intel® Technical Advisory

TA-0414-05

Timing Margin Increased On SKA4 Baseboards

SKA4 Baseboard Resistor and Label Locations.

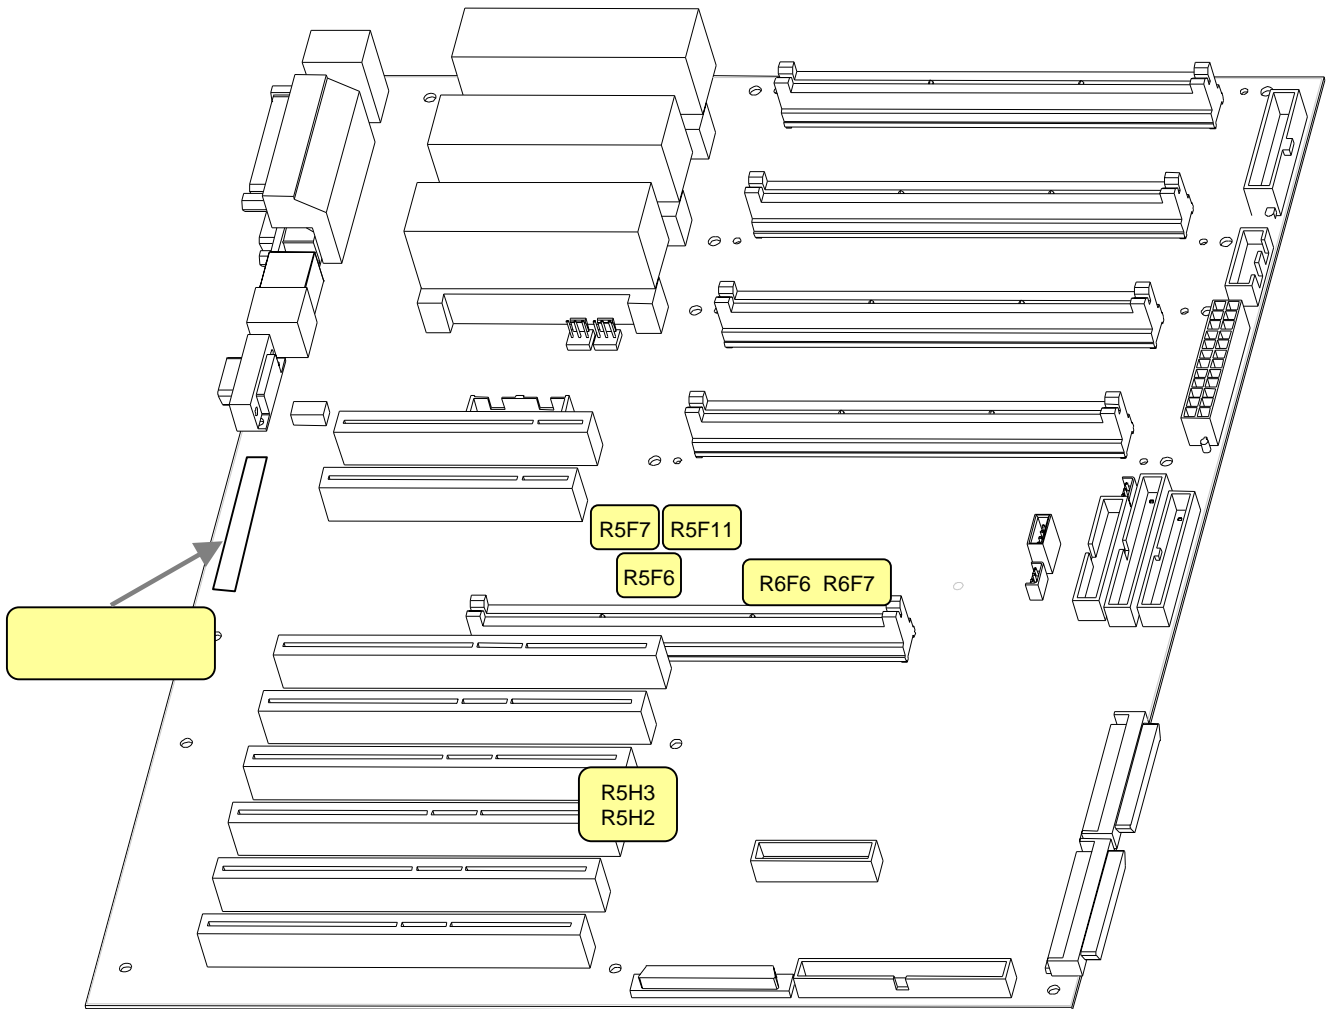
Intel has implemented a resolution to this issue by reconfiguring the chipset IMB bus. The resolution involves changing the baseboard by removing three resistors and adding four other resistors as shown below. These changes configure the chipset IMB bus to provide additional timing margin. As a result, the PCI-A bus will continue to be set at an operating speed of 33 MHz to match system specifications and the option to change this bus speed to 66 MHz via BIOS setup is removed.

Remove the resistors from the following locations:

R5F7
R6F6
R5H3

Add resistors to the following locations:

R5F11 (0 ohm, 5%, 1/16W)
R5F6 (0 ohm, 5%, 1/16W)
R6F7 (1k, 5%, 1/16W)
R5H2 (1k, 5%, 1/16W)

Update to BIOS 52.1, which incorporates changes required for compatibility with the fore mentioned hardware changes.

NOTE: BIOS versions prior to BIOS 52.1 are not compatible with the fore mentioned hardware changes. In general, a BIOS earlier than BIOS 52.1 will work, however, if it is used in combination with a 66 MHz capable adapter installed in the PCI-A bus, abnormal behavior, including lockup of PCI Bus A, may occur. Please see the following *Table 1: PBA Board revision and BIOS Support* for more information and compatibility.
